**E5071B-08C**

# **S E R V I C E                      N O T E**

## **E5071B ENA Series Network Analyzer, 300 kHz to 8.5 GHz**

**When a measurement trace or output power shows troubles between 1.3 GHz and 2.1 GHz, replace A1 module with the latest one (E5071-6x571), and update E5071B Operating system at the same time.**

Figure 1. Trace shows noise around 1.3 GHz to 2.1 GHz at preset setting.

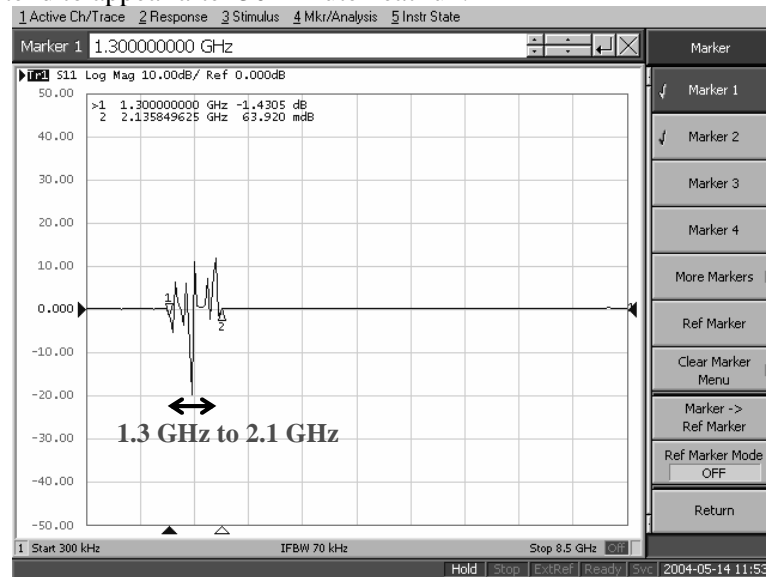
The E5070B and E5071B's A1 source board E5071-6x551 and E5071-6x561 module had high-failure rate component parts problem, thus it was re-designed to improve its reliability as E5071-6x571.

When the high-failure rate part has defective, the unit cannot output correct power level source or local signal, between 1.3 GHz and 2.1 GHz frequency range.

- The trace shows spike at 1.3 GHz or 2.1 GHz at the preset situation.
- The trace between 1.3 GHz to 2.1 GHz is more noisy than other frequency ranges.
- The power level of 1.3 GHz to 2.1 GHz is lower than other frequency ranges.
- Internal test of A1 ALC shows fail at SOP (f=1.3G) or LOP (f=1.3G) as Figure 2.

Above symptoms tend to appear after 30-minute heat run.

Replace the defective board with E5071-6x571, new A1 module. Also, update the operating system in accordance with the service note E5071B-10A to implement the firmware revision 5.00 or later. \*1
